FAQ Number 18-0019 FAQ Revision 0 (Draft v6)

FAQ Title Transient Fire Heat Release Rate Curves

Plant: Various Date: March 13, 2019August 22, 2018

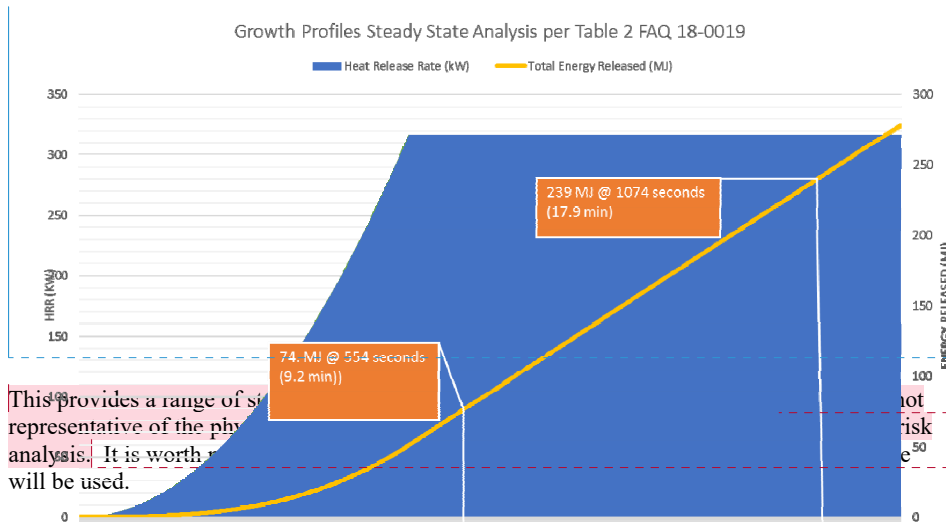
**Commented [MN7]:** This would be a more illustrative tool if the HRR's were normalized to show how the new generic HRR profiles match up with previous test data

**Commented [MB8]:** None of the fires in this table were 317 kW.
